# WELDING INSPECTION REPORT

PP57-DP117-002 – 058.

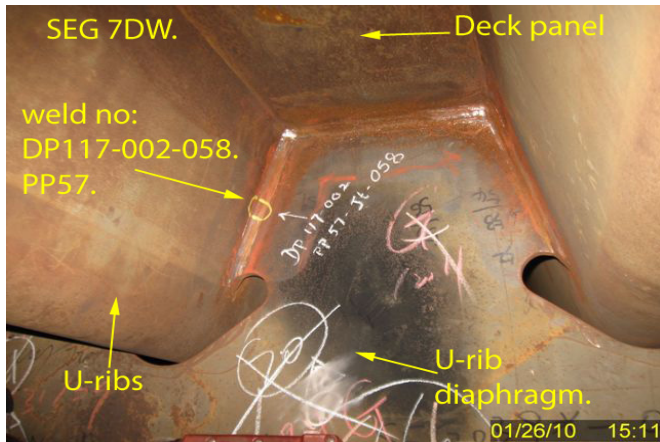
One (1) transverse linear indication was discovered measuring approximately 6mm in length. The member is identified as the deck panel diaphragm, fillet weld connection to U-ribs. This indication is located outside the area that has been previously tested and accepted by ZPMC Quality Control (QC) personnel. This QA informed ZPMC Quality Control (QC) identified as Mr. Wang Wei Ming and American Bridge Fluor (ABF) QA identified as Mr. Peter Shaw of this issue and that an incident report would be generated.

For further information, please see the attached photos.
